BIG ROCK POINT - TYPE "J-2" $\text{UO}_2\text{-PuO}_2$ FUEL

Change No. 27
License No. DPR-6

CHANGE NO. 27 TO THE TECHNICAL SPECIFICATIONS

Jersey Nuclear Com
FUEL BUNDLE
DETAILS
B. S. R. P. M. P. M.
JN-12-3203 2

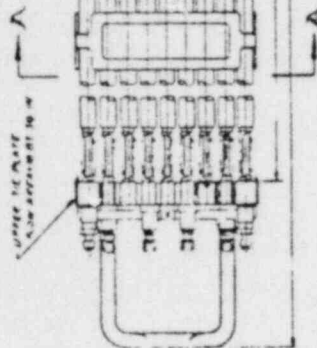
2. Add Figure 5.7, Big Rock Point Type "J-2 (UO₂-PuO₂)" Fuel, to Section 5.
3. Add the attached column and footnotes to Table 5.1 of Section 5.1.5.
4. Change Column 2 heading of Table 5.2 in Section 5.2 to read:
